***Development Special Use Permit #2014-0043  
Restaurant Special Use Permit#2015-0096  
Transportation Management Plan SUP #2015-0095  
1101 North Washington Street – Old Colony Inn***

Application	General Data	
<b>Project Name:</b> 1101 North Washington Street	PC Hearing:	May 3, 2016
	CC Hearing:	May 14, 2016
	If approved, DSUP Expiration:	May 14, 2019 (3 years)
	Plan Acreage:	0.98 acres (42,746 SF)
<b>Location:</b> 1101 N. Washington Street	Zone:	CD / Commercial Downtown
	Proposed Use:	Hotel/Restaurant
	Dwelling Units:	N/A
	Gross Floor Area:	62,403 SF
	Net Floor Area:	58,539 SF
<b>Applicant:</b>	Small Area Plan:	Old Town North
	Historic District:	Old & Historic Alexandria
	Green Building:	LEED Silver or equivalent

<b>Purpose of Application</b>
Consideration of a request for a Development Special Use Permit with Site Plan for renovation of and addition to an existing hotel with accessory restaurant/meeting room.
<b>Special Use Permits and Modifications Requested:</b>
1. Development Special Use Permit and Site Plan with modifications for renovation of and addition to an existing hotel with accessory restaurant/meeting room, and a request for a parking and loading reduction; 2. Sp

Figure 2: Zone Transition Setback (from Second Street)

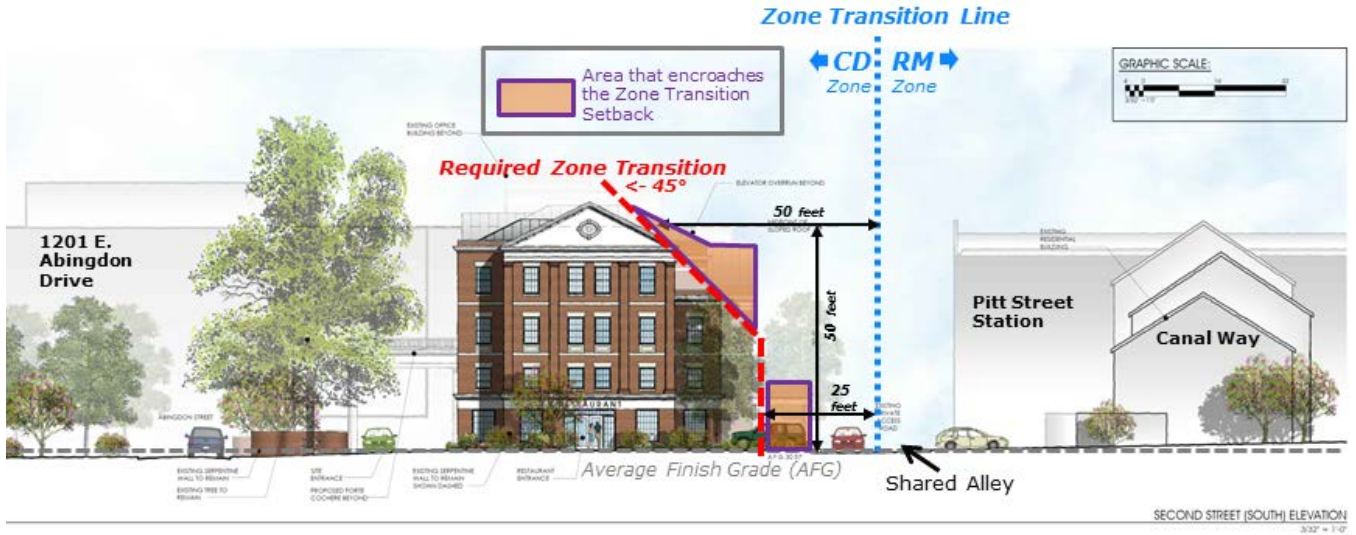
1. The modification allows for the design of an architecturally balanced and articulated building. The applicant is utilizing the existing building footprint and superstructure for their expansion, which places constraints on how the building is oriented on the parcel. As seen in Figure 3 below, removing the encroaching elements of the building (in green) would compromise the architectural character of the building, and render portions of the third and fourth floor unusable. The building height of 50 feet conforms to the height permitted in the CD zone and is similar to the heights of nearby residential and commercial buildings.

2. The parts of the proposed building expansion that encroach into the transition setback are related to specific architectural details that enhance the overall building design. These include, among others, the hipped roof on the fourth floor, the gable pediment at the third floor and the cornices and eaves of the third and fourth floors. Additionally, the covered entrance along the eastern building façade, a building element that encroaches into the zone transition line setback, adds character and architectural interest to the building with no impact on neighboring properties. In addition to enhancing the appearance of the hotel, other elements of the site and building design that compensate for the encroaching portions of the building include increased landscaping and an improved pedestrian access, which enhance both the shared alley and the Second Street frontage.

3. Staff supports this modification on what is considered a minimal building encroachment of the zone transition line setback in support of an overall enhancement of both the current hotel building as well as its property. Mitigating the encroachment is the considerable distance between the rear facades of the Canal Way townhomes and the eastern building façade (at least 70 feet) and the variations in heights of the proposed building. A townhouse solution for this site would not be subject to the zone transition line setback. As proposed, staff does not find that the building encroachment will be detrimental to neighboring properties with regard to access to air or natural light.

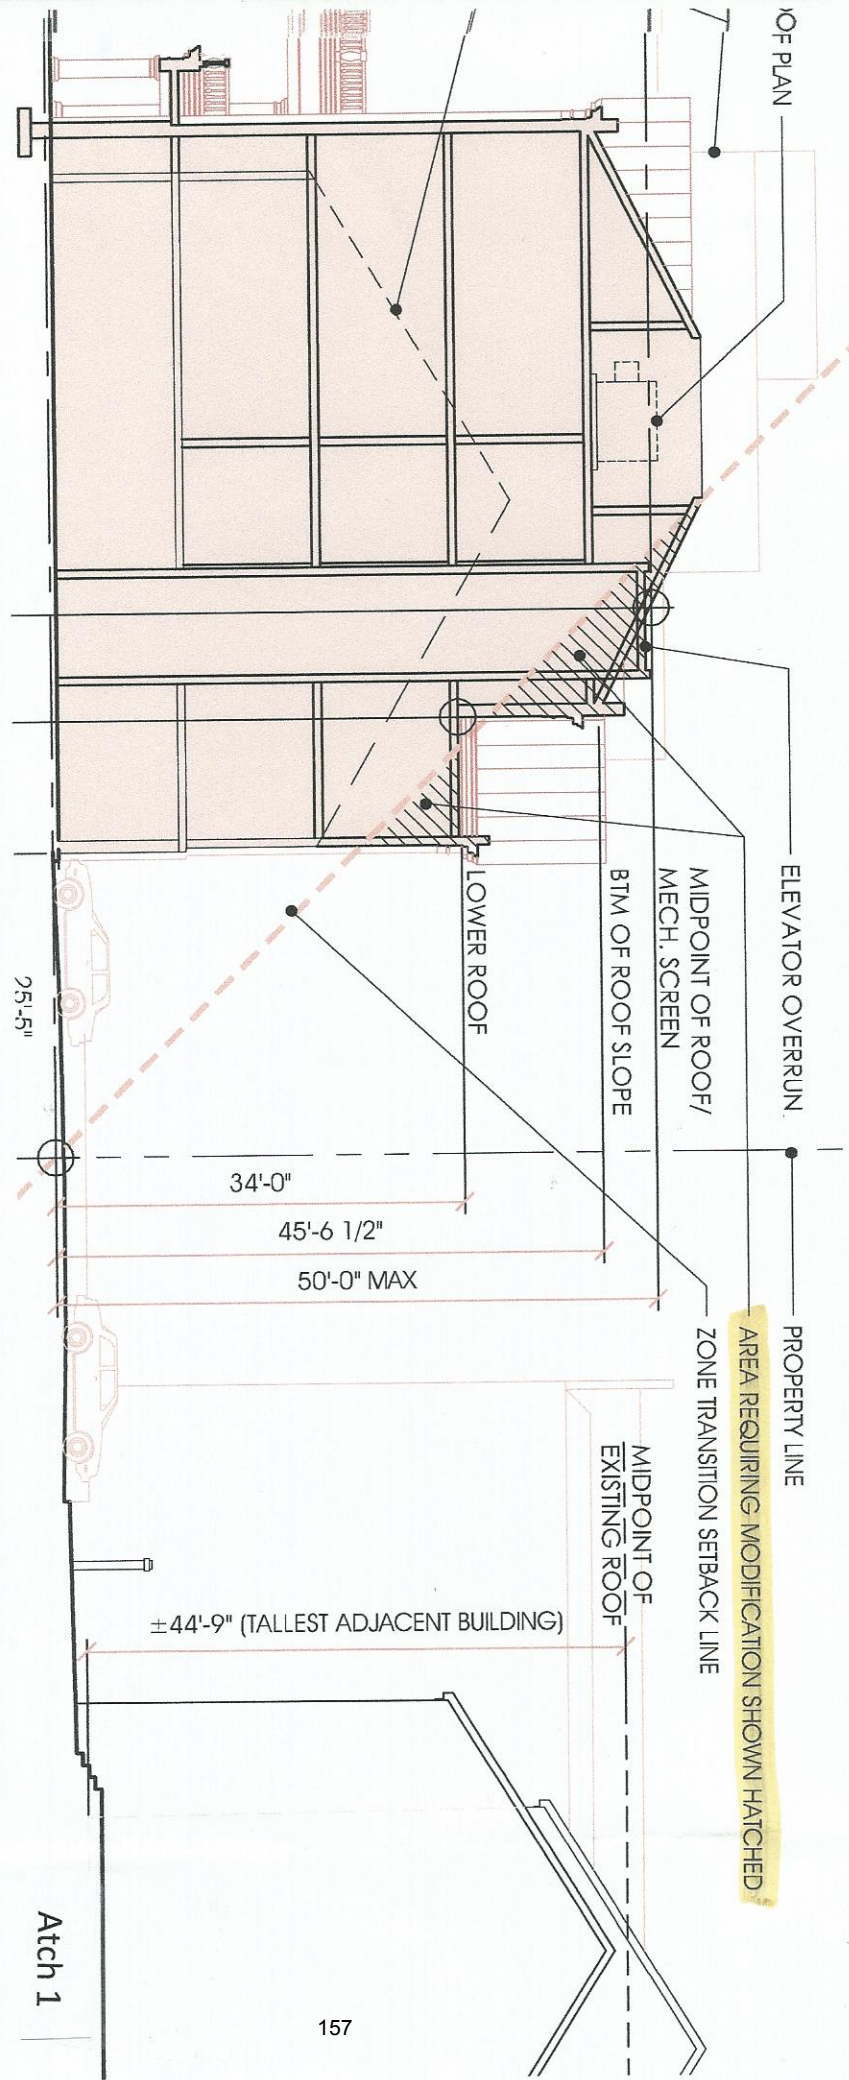
\* The long back side center section of this proposed building seriously encroaches in the Zone Transition Setback mandated by City Zoning Code.

\* **Any** modifications to the zone transition line setback as it applies to the **center section** of the building **should not be approved**.

# Old Colony Inn Hotel Zone Transition Setback Violation (hatched areas)

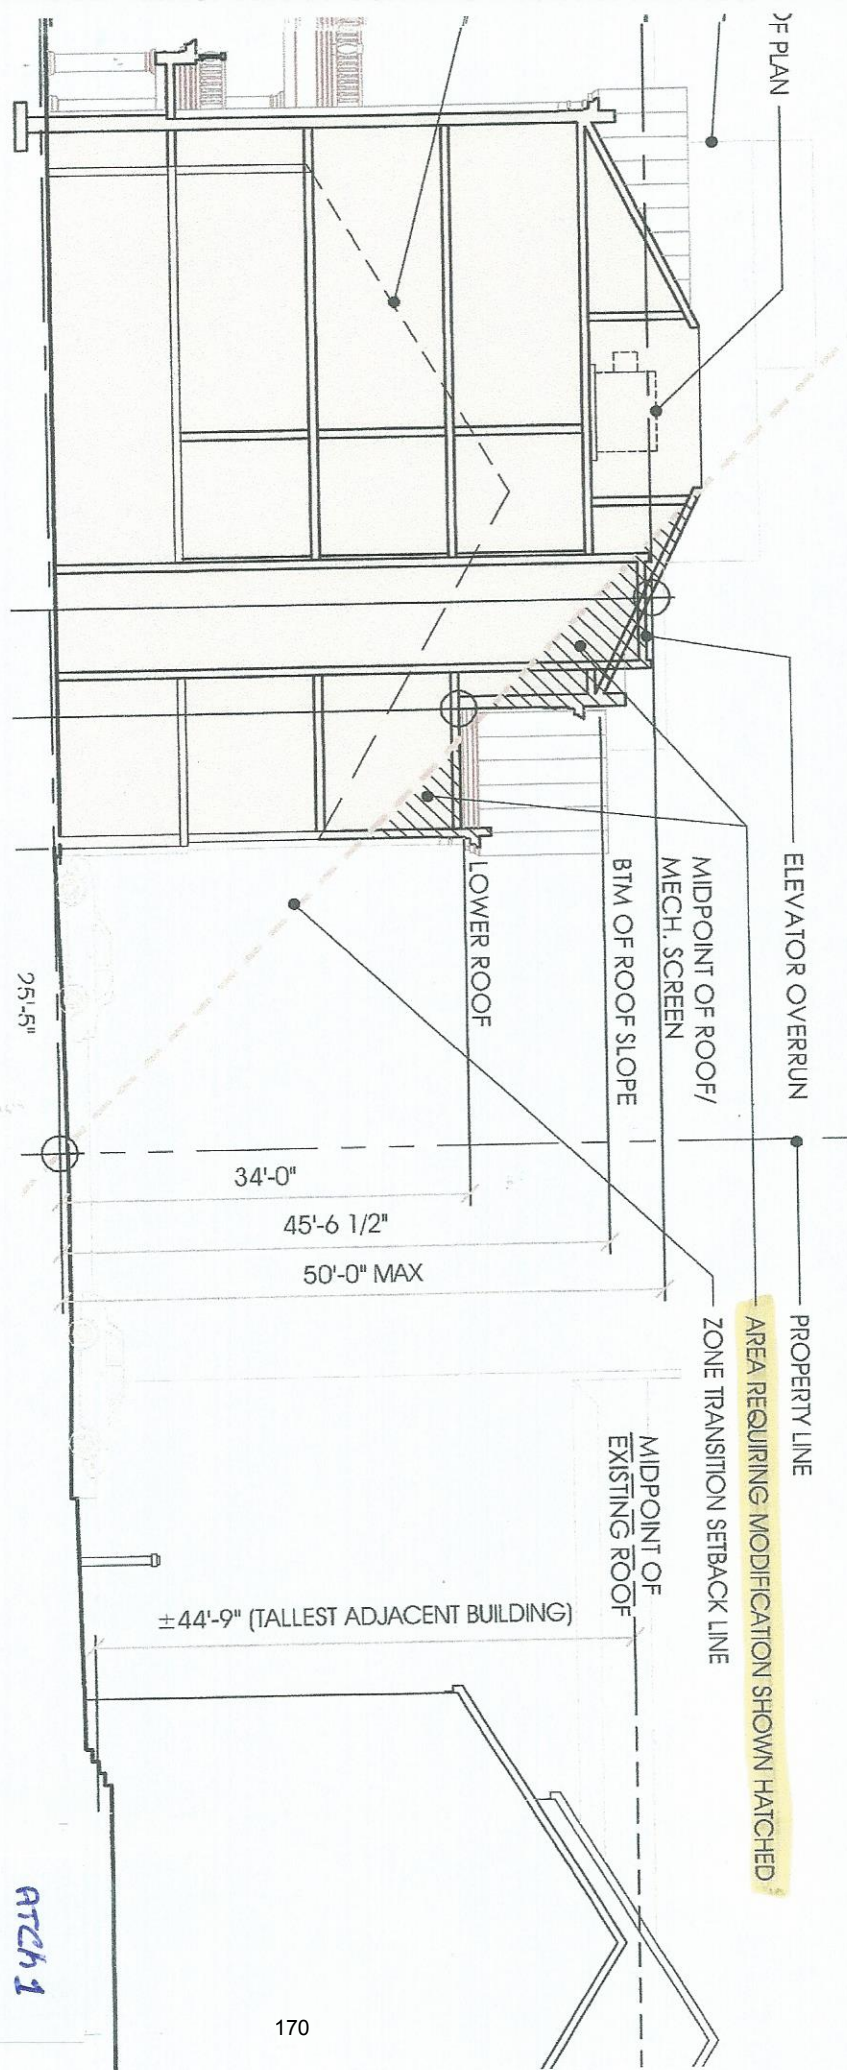
Atch 1: Depiction of Setback Violations  
Atch 2: Excerpt—Washington Street Standards  
Atch 3: Jinks Ltr, 29 March 2016
